ADDENDUM NO. 7

Re: Arch Job Number 24001, DCM #2025238, – Plans Dated: 3/31/25

New Lincoln Police Department

Revised Sheet M3.2 ATTIC HVAC PLANS

M3.2

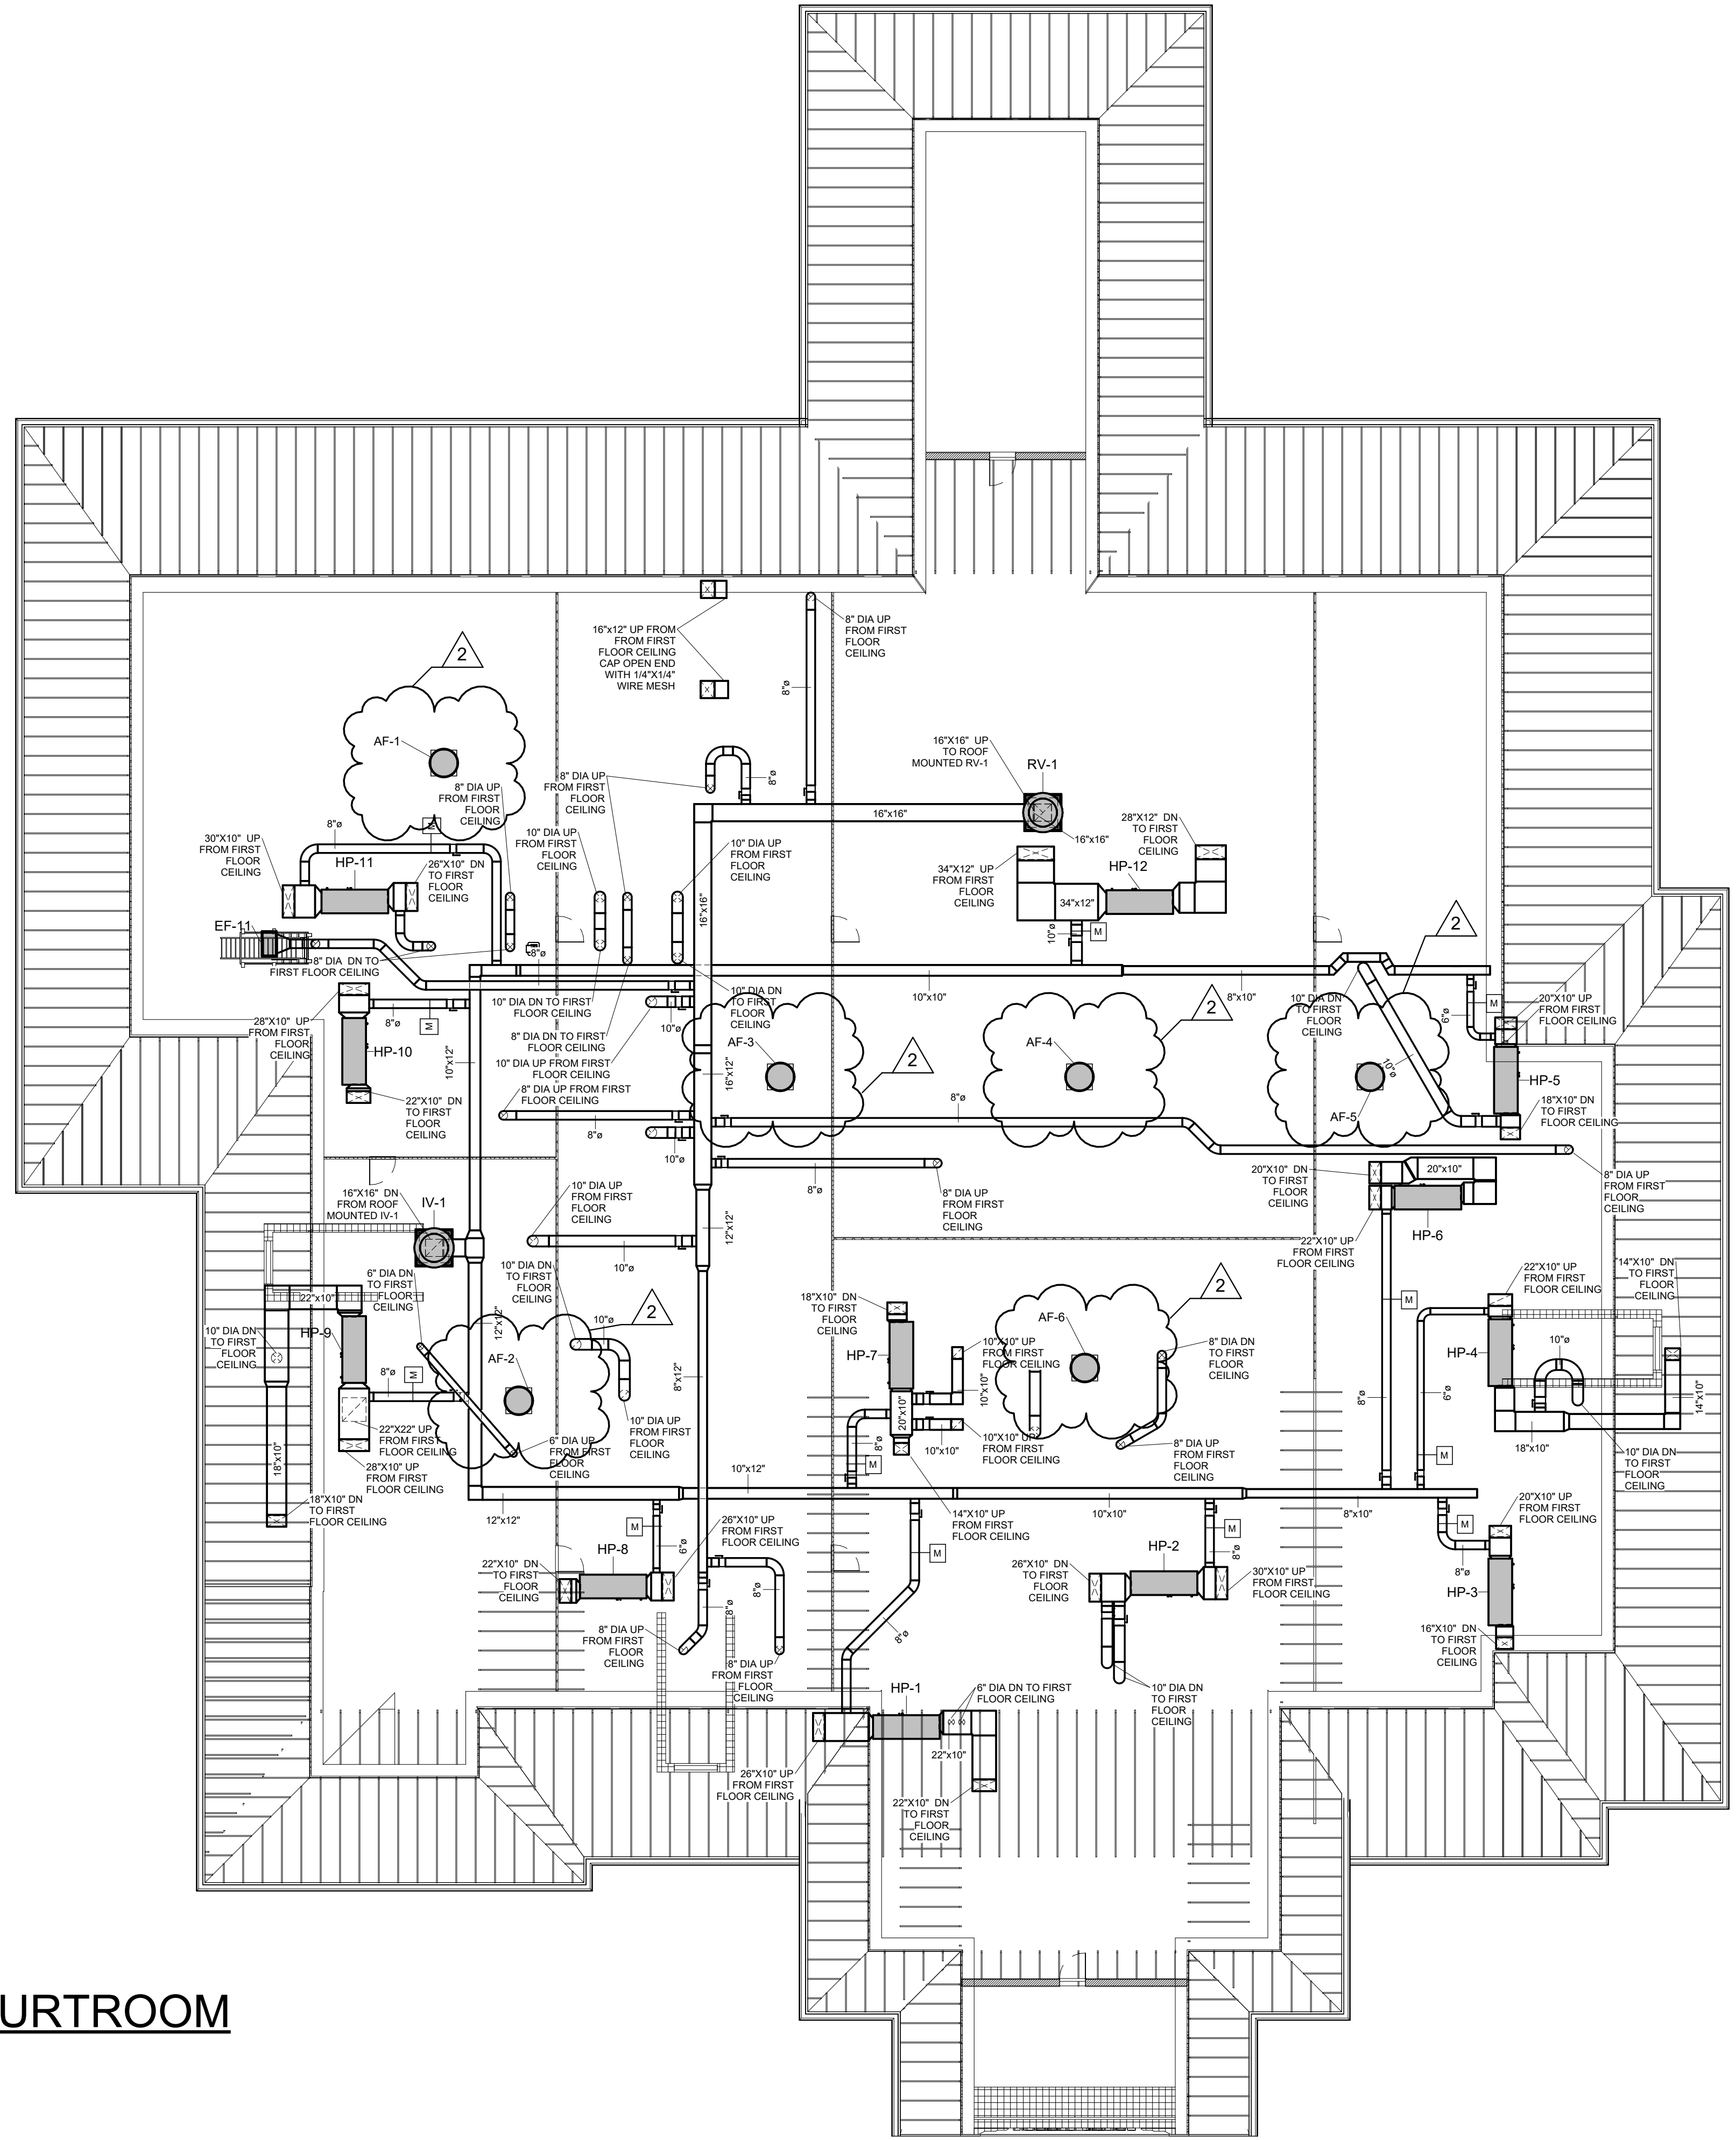
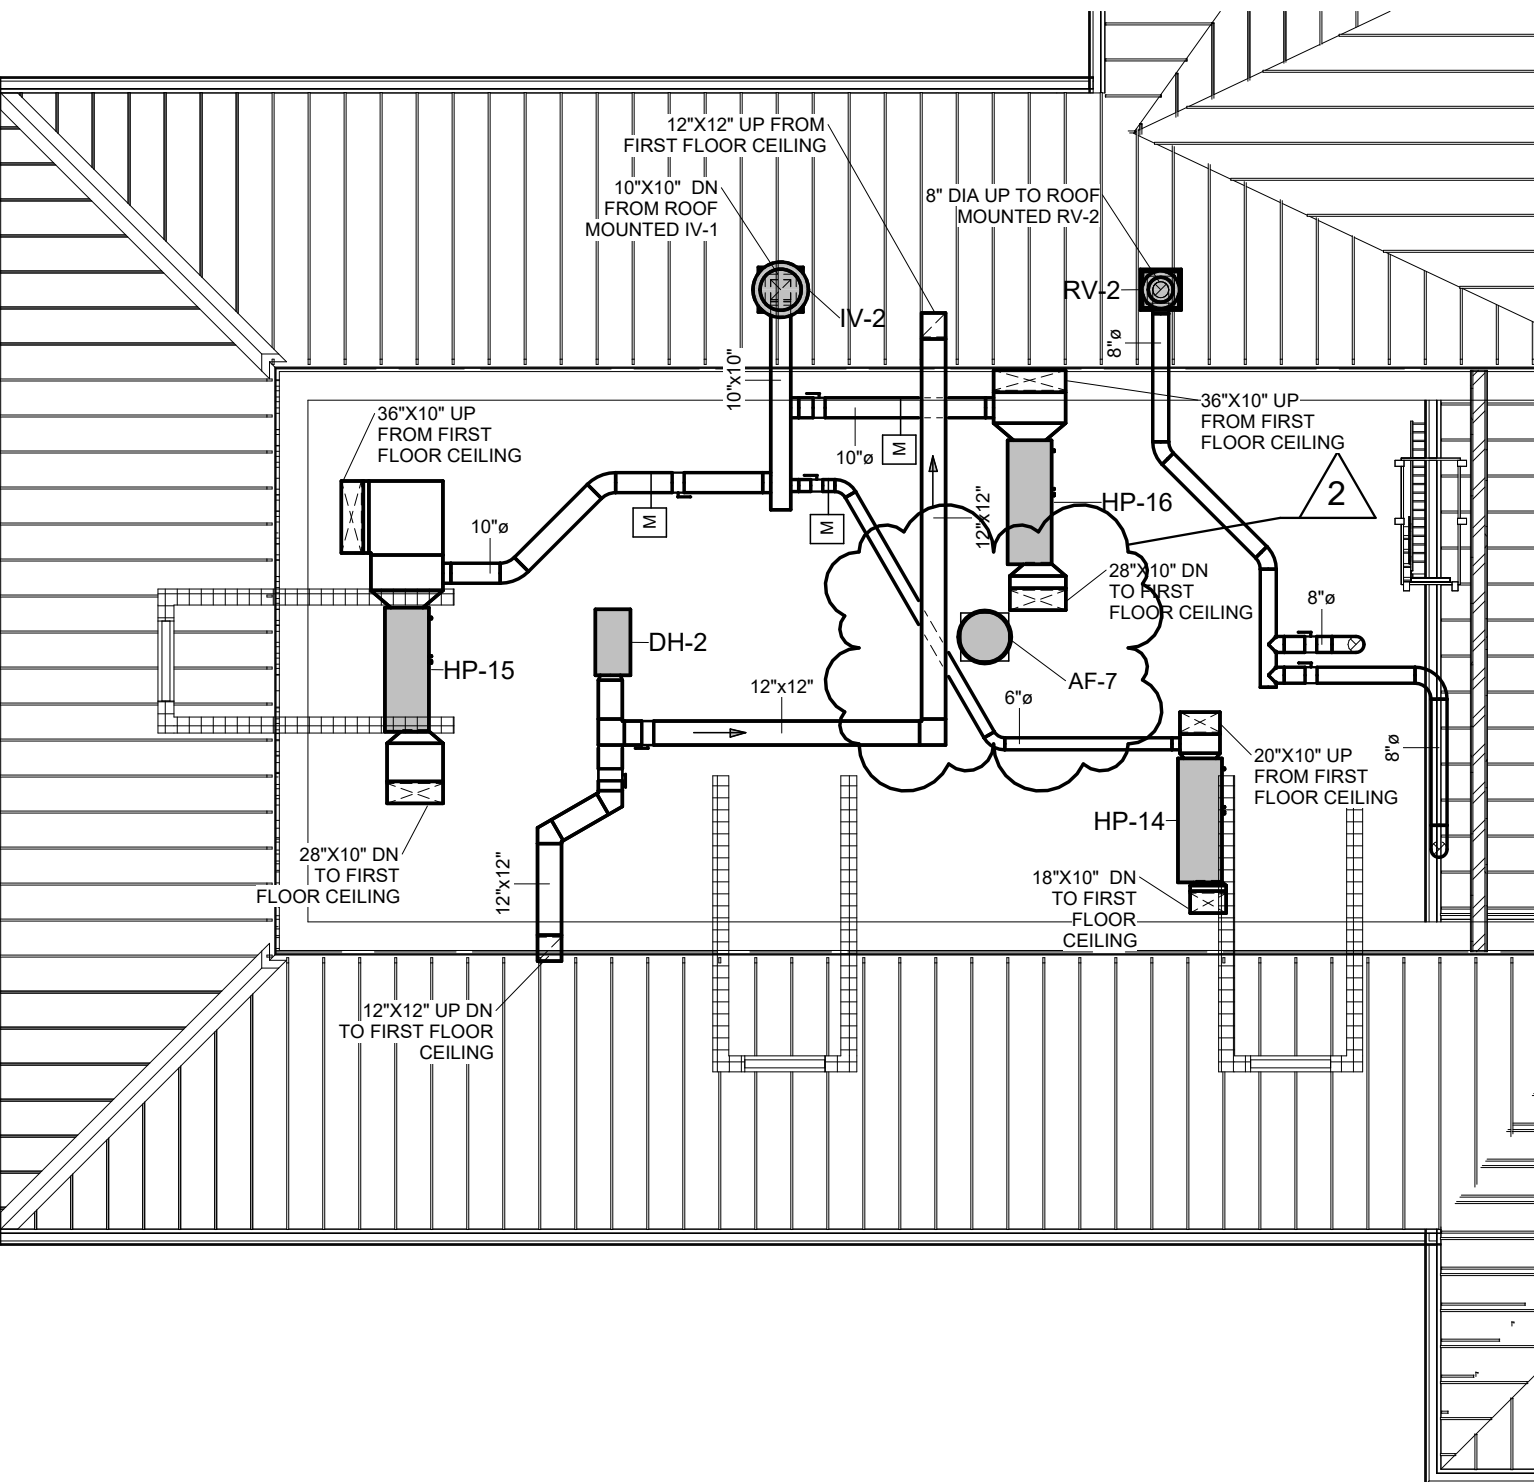
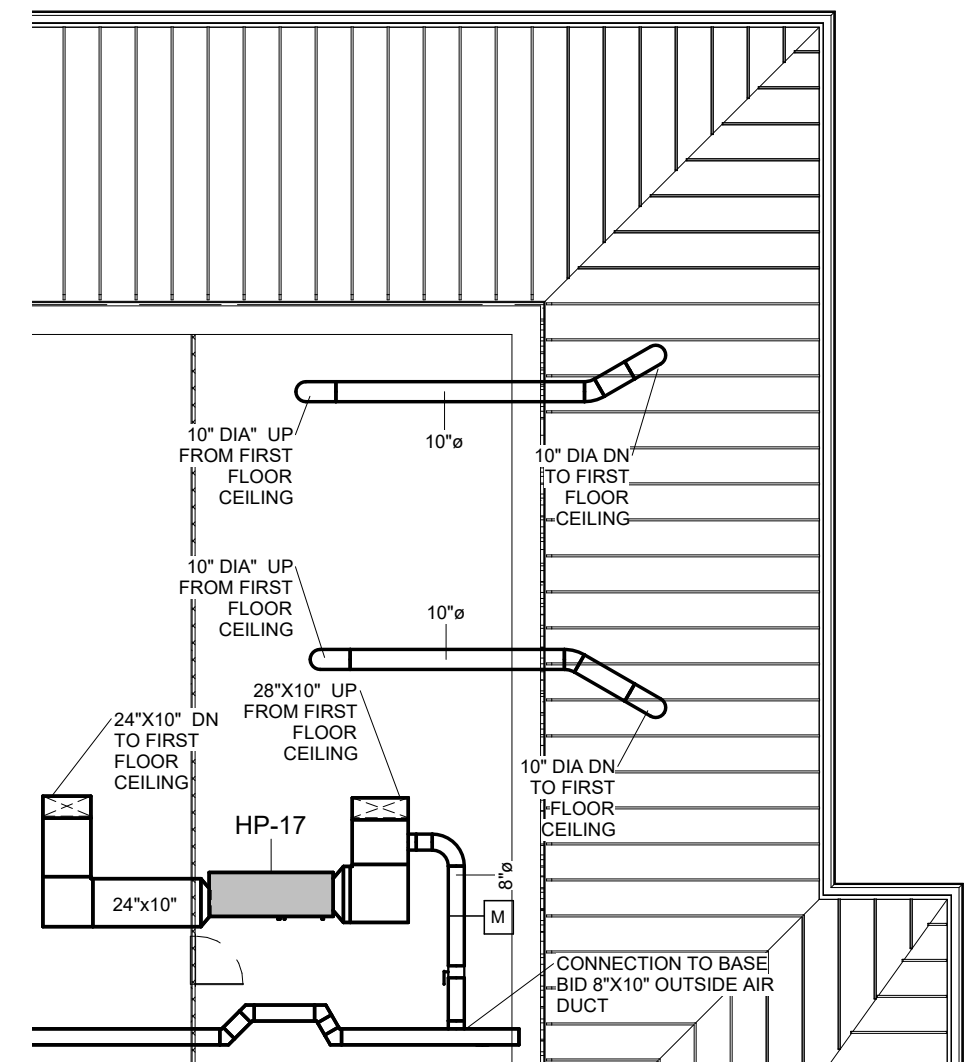
1. Mechanical drawings have been revised to indicate mechanical attic venting equipment. See revised mechanical drawings for modifications to the scope of work. Also see attached mechanical addendum narrative. **Color of mechanical equipment to match roof color** which is to also match Lincoln City Hall. Also note that the revised electrical drawings in addendum 6 already show these attic vents.
2. Mechanical: Daikin equipment is an approved equal.

1. **Reference Sheet M3.2:** Add seven attic ventilation fans AF1 – AF7 for attic ventilation. AF-7 shall be included in Alternate. Reference attached plans for location. Fan shall be equal to Master Flow ERV4 and shall include factory humidistat/ thermostat. Color shall be selected by Architect prior to installation. Color selections shall include black, brown, and color match. Fan shall be 1000 cfm, 120-1-60. Coordinate final location with architect prior to installation. Coordinate all electrical with electrical subcontractor.
